REGIONAL DISTRICT OF NANAIMO

REQUEST FOR TENDER No. 23-043

Maffeo Sutton Screen Chamber – Access Improvements

Addendum 1 (9 pages total)
Issued: July 4, 2023

DWG NO: **S02** REV: **D**

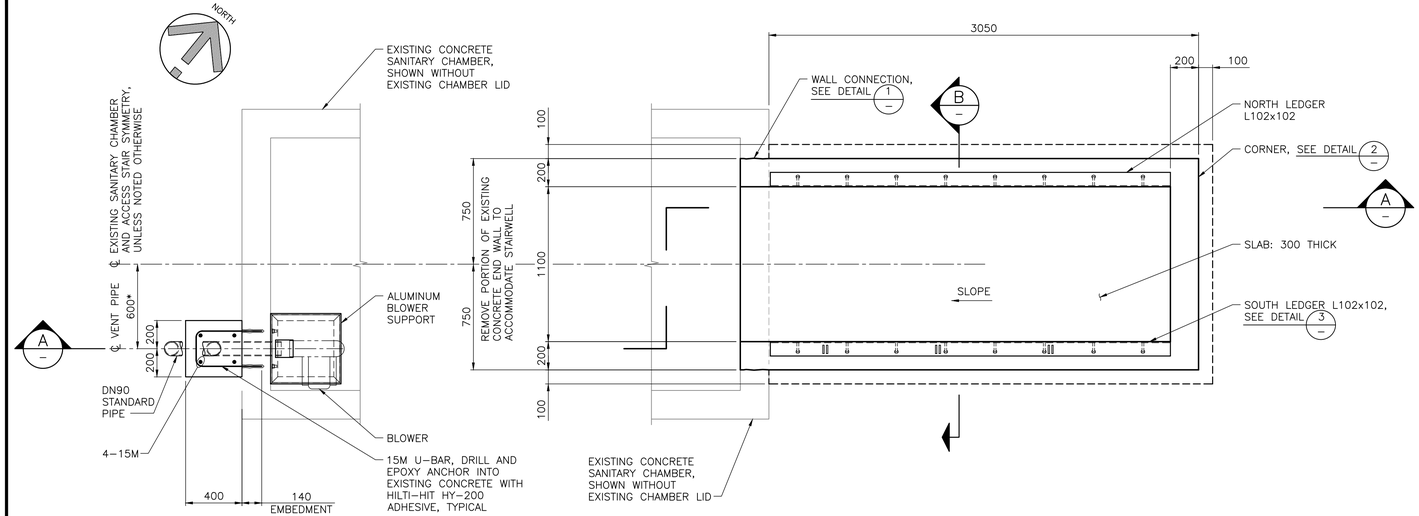
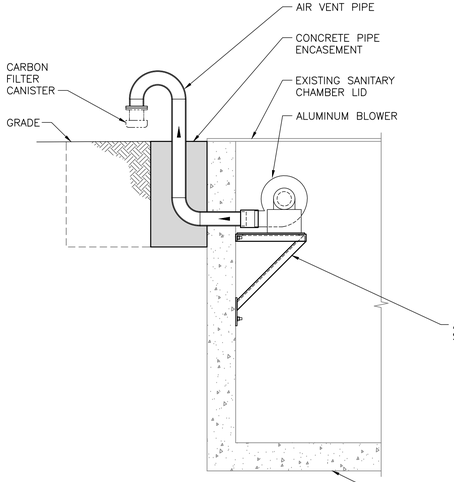
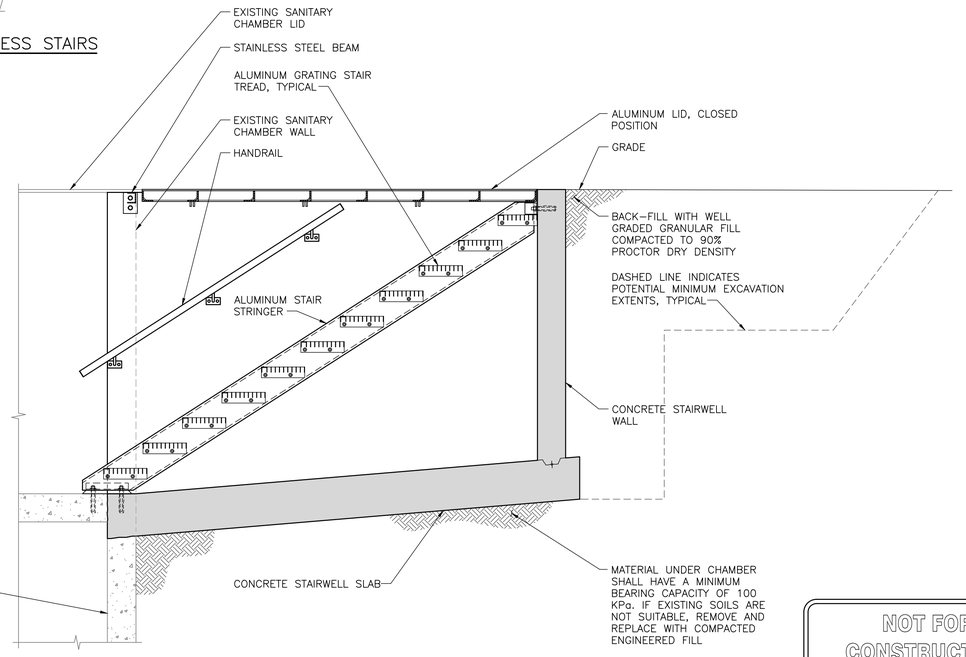
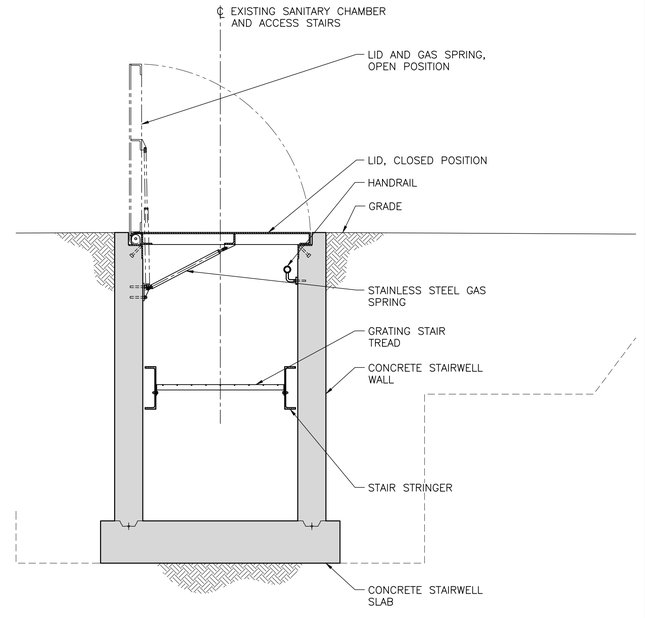
1. Please find enclosed a copy of the Tenderer's Site Meeting Sign-In sheet.
2. Please find enclosed an updated copy of the 'Issued for Tender' **Herold Engineering drawings S01 through S05 Revision 'D'** which supersede the Revision 'C' drawings included in the original tender documents. The updates include details regarding excavation, backfill and the minimum required bearing capacity of the in-situ soil, shown on **drawing S02**.

For clarity, the RDN will arrange for inspection of the stairwell subgrade to confirm soil bearing capacity and suitability. Any additional measures (e.g. over-excavation and/or bedding) required to make a suitable subgrade would additional to the Contract Price.
3. The fibre-reinforced plastic (FRP) lid on the existing chamber will be required to be removed to facilitate cutting and removal of the stairwell opening to the existing chamber. The FRP lid must be put back in place at the end of each day and a plastic sheet covering placed over the opening in the existing chamber to contain odours outside of working hours.
4. The temporary construction fencing around the work area shall include a privacy screen due to the sensitive cultural nature of the excavation.
